## **Speech Notes from Joy Brookes**

### **Planning Assessment Commission Meeting**

#### **Redevelopment of the Australia Technology Park, SSD 15\_7317.**

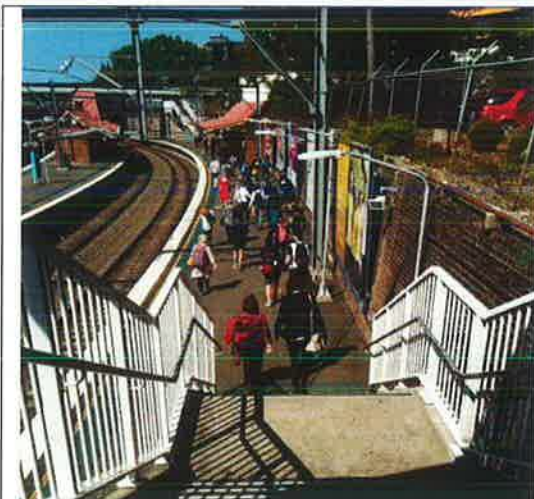
That exit is approx 2.3 metres wide at the top of the steps with two opal readers.

According to Opal, each pass takes 3 - 5 seconds. If 3 seconds that would mean

Only 2,400 could tap and pass in one hour. If it only took 2 seconds it would be 3,600.

But there would be 4,100 new workers plus children going to Alexandria park Community school, plus existing ATP and other local workers, plus locals going in the opposite direction, plus arrivals for the intensive English High School (current enrolment approx 600) who will relocate to Alexandria in 2018.

Will there be a queue snake along platform 10, the pathway to this exit?

And a snake on the other side trying to access Redfern Station?
